# Genesis Waste Management Facility Modification 6 (MP 06\_0139 MOD 6) Submission on behalf of Jacfin Pty Ltd – Hours of Operation and Landfill Cap

Re: Genesis Waste Management Facility Modification 6 (MP 06\_0139 MOD 6) – review of Air Quality

Re: Genesis Waste Management Facility - Modification 6 (MP06\_0139 MOD6)

Noise Peer Review on behalf of Jacfin

Figure 1 Noise Emission Zones

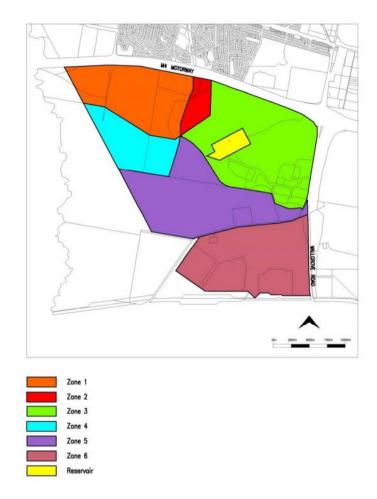
The Eastern Creek Precinct Plan (Stage 3) (**Precinct Plan**) sets noise level goals for land within the Eastern Creek Precinct to ensure the amenity of surrounding residential areas is protected. The Noise Impact Assessment does not include any consideration of these noise goals.

The subject site is located in Zone 1 and therefore has a noise goal of 57dBA during the day, 47dBA during the evening and 42dBA at night.

It is recommended the Modification 6 noise assessment consider the Precinct Plan to ensure that future ambient noise levels are consistent with noise expectations of the area.
